Site Design Review of Tract A Open Space Spring Terrace Subdivision

DRB Panel A Public Hearing

July 13, 2026

Site Design Review

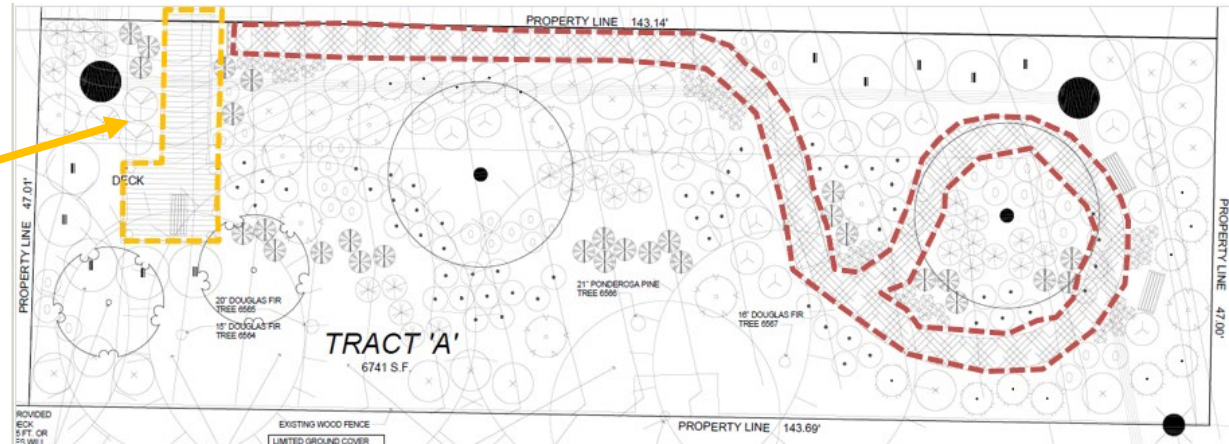
- Original design included ramped pathway over stormwater easement

- New design has walkway to raised deck/platform in lieu of ramped pathway
